DRAINAGE LETTER REPORT

NOR'WOOD BIBLE CHURCH LOT 38, SADDLEHORN RANCH FILING NO. 3

October 13, 2023
Revised January 15, 2024

**JPS Project No. 042303
PCD Filing No. PPR2346**

Culvert Report

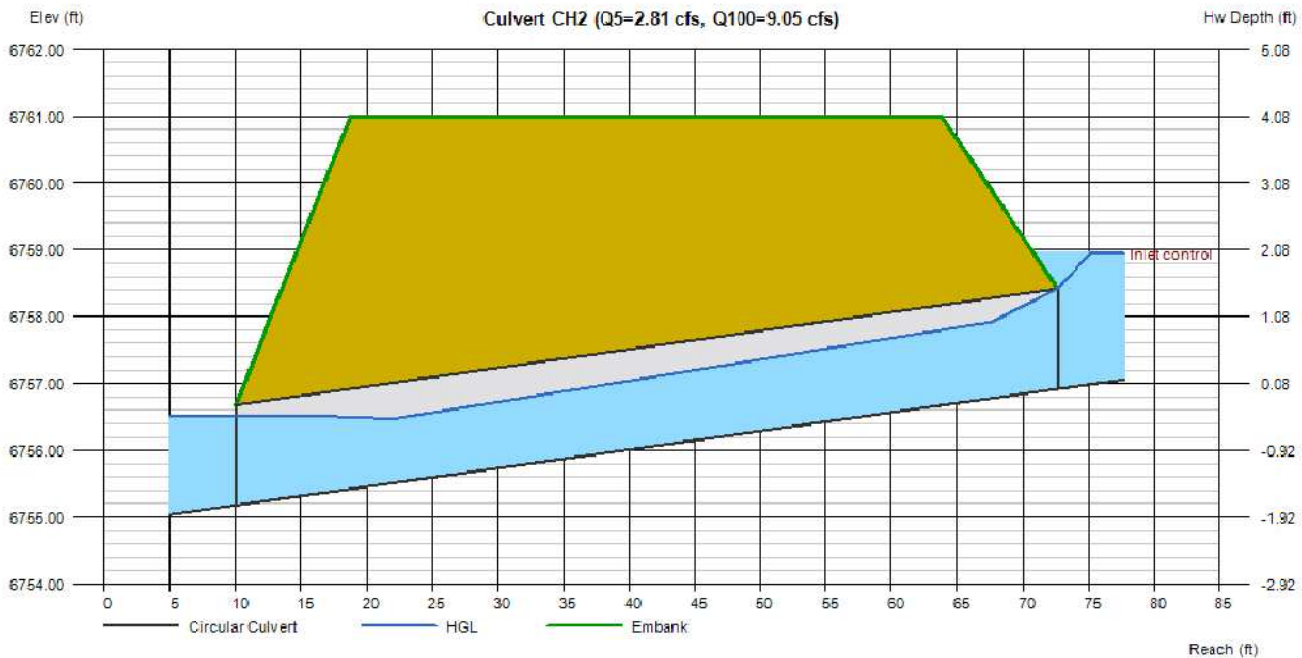
CALCULATED FLOWS FOR BASIN CH2 (APPENDIX B):
 Q5 = 0.9 CFS; Q100 = 2.5 CFS) ARE WELL BELOW THE ESTIMATED
 FDR FLOWS IN THIS CALCULATION

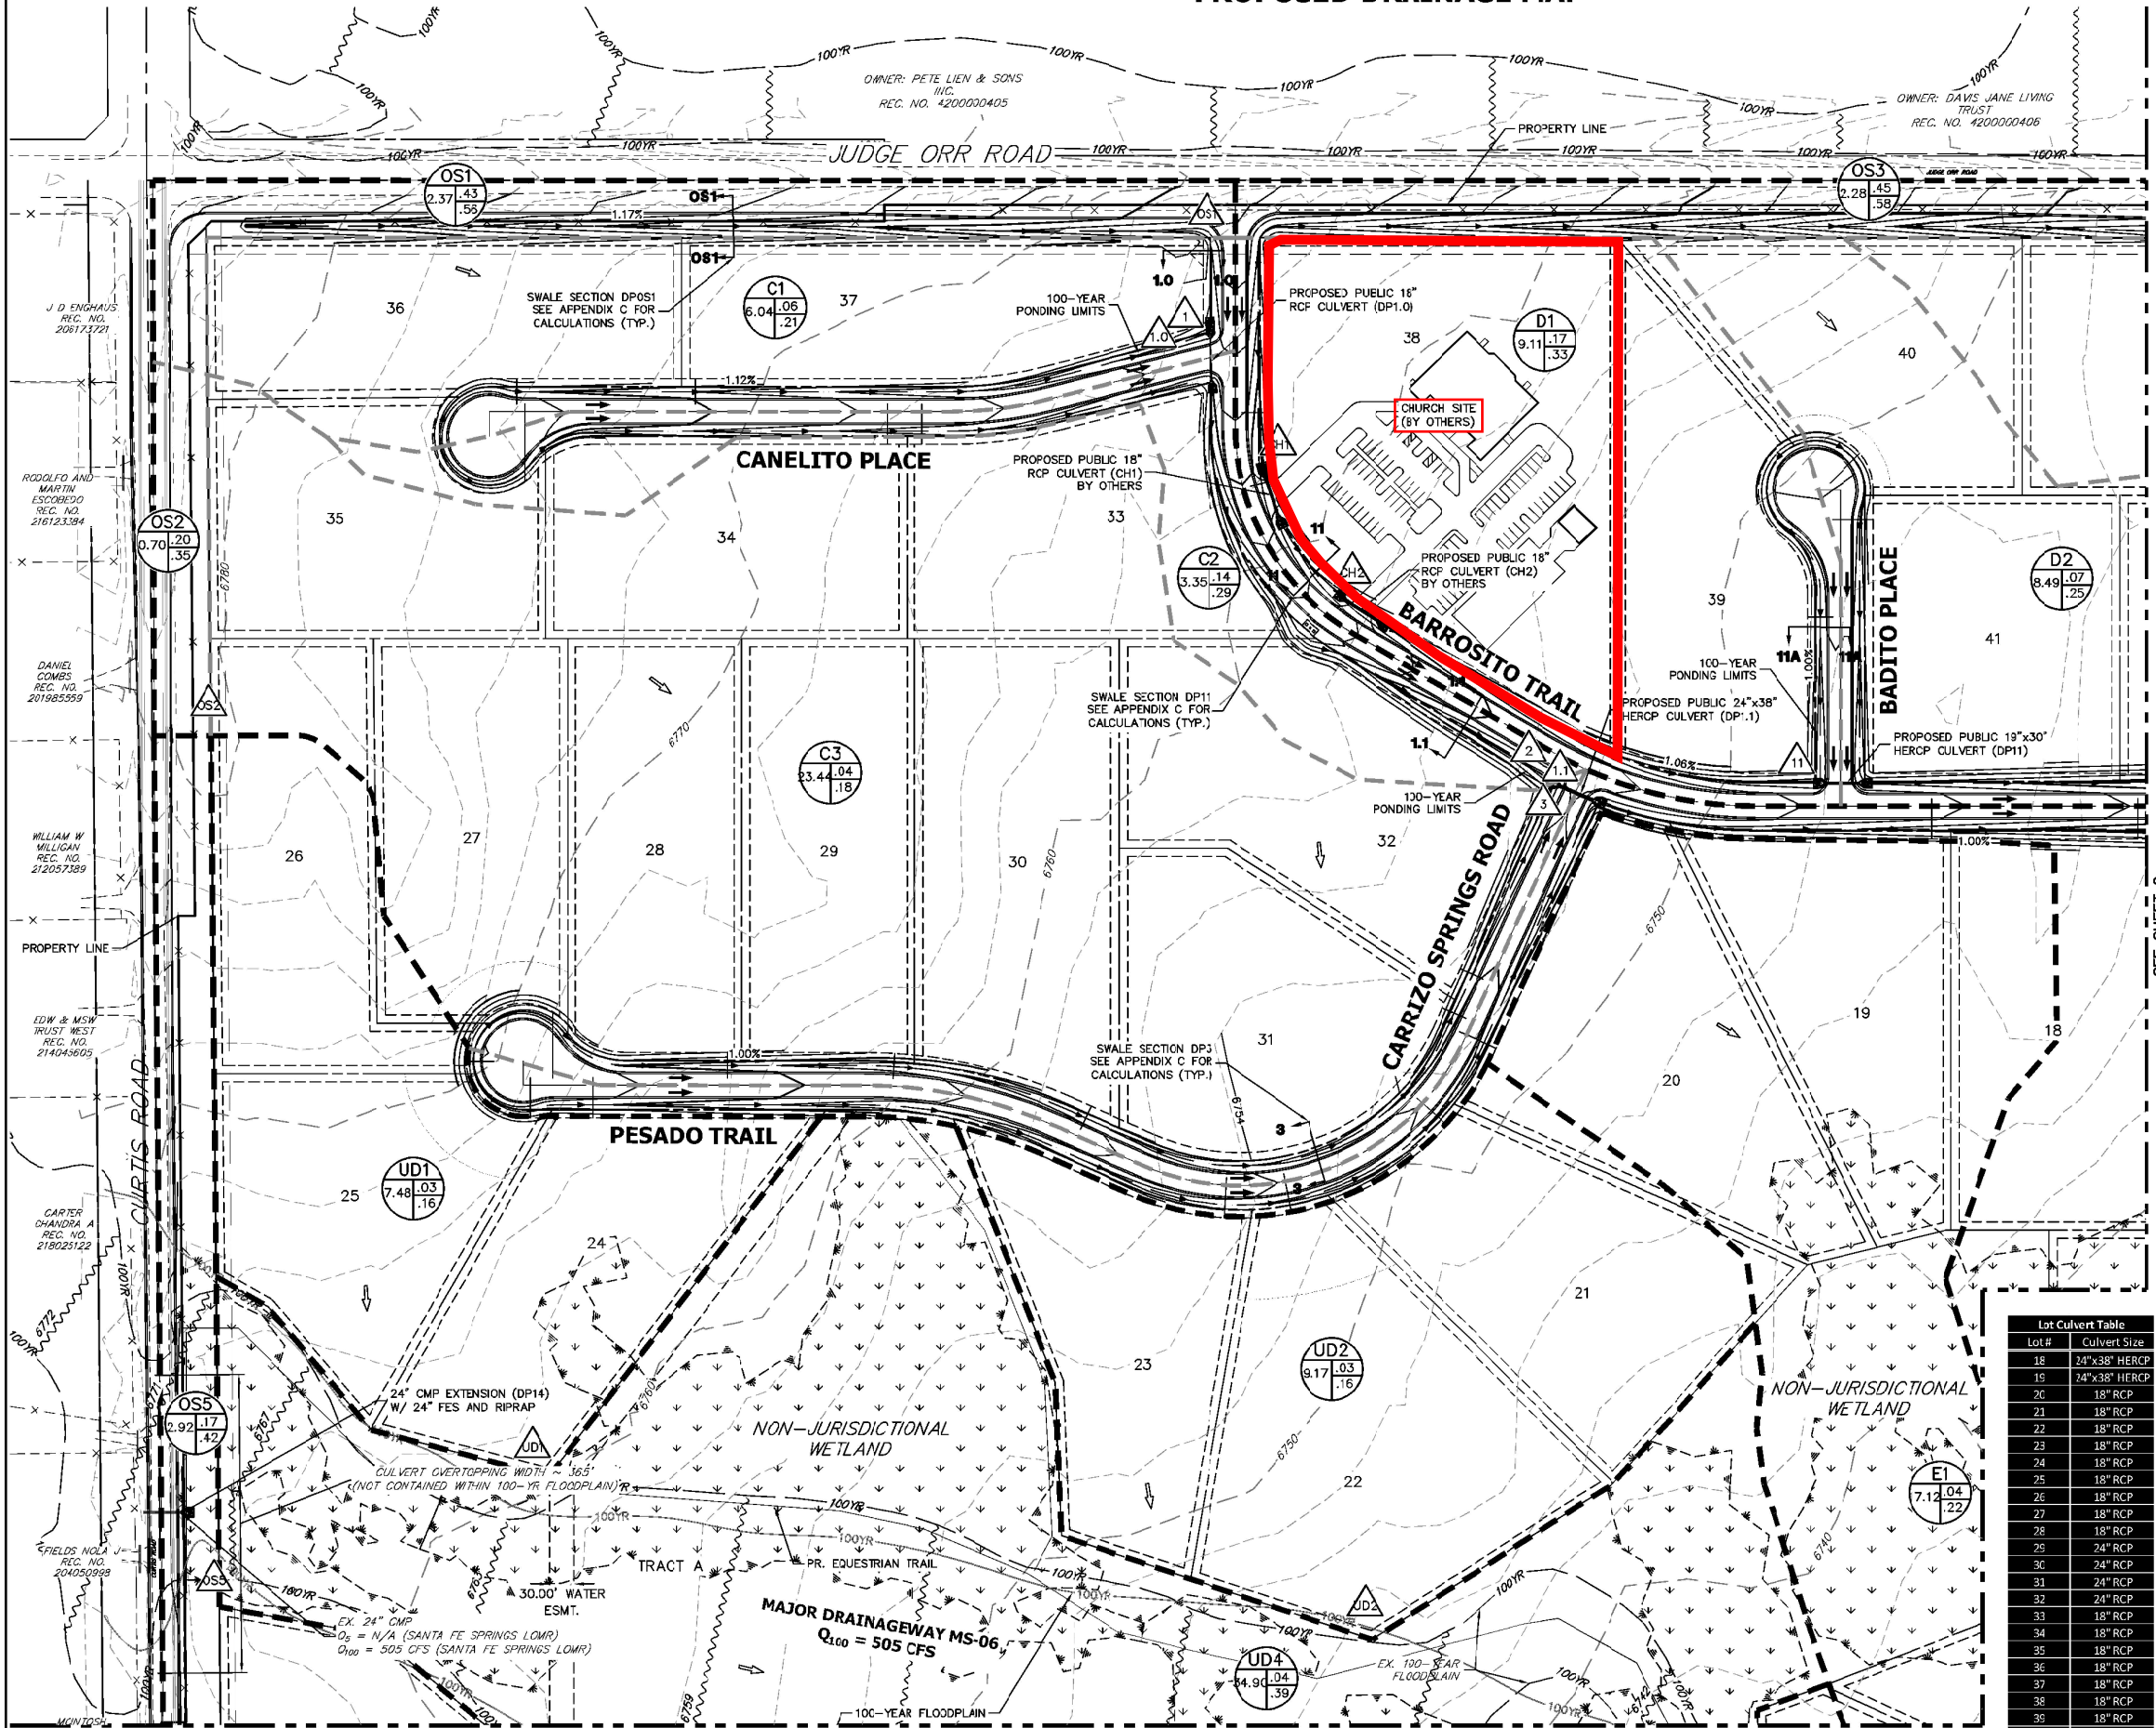
This culvert will be constructed by a different contractor alongside construction of the church site. The estimated flow being captured by this culvert is estimated to be 67% of the flow generated by Basin D1. This flow estimate is larger than what will actually flow to this culvert given where the culvert is placed in relation to the basin.
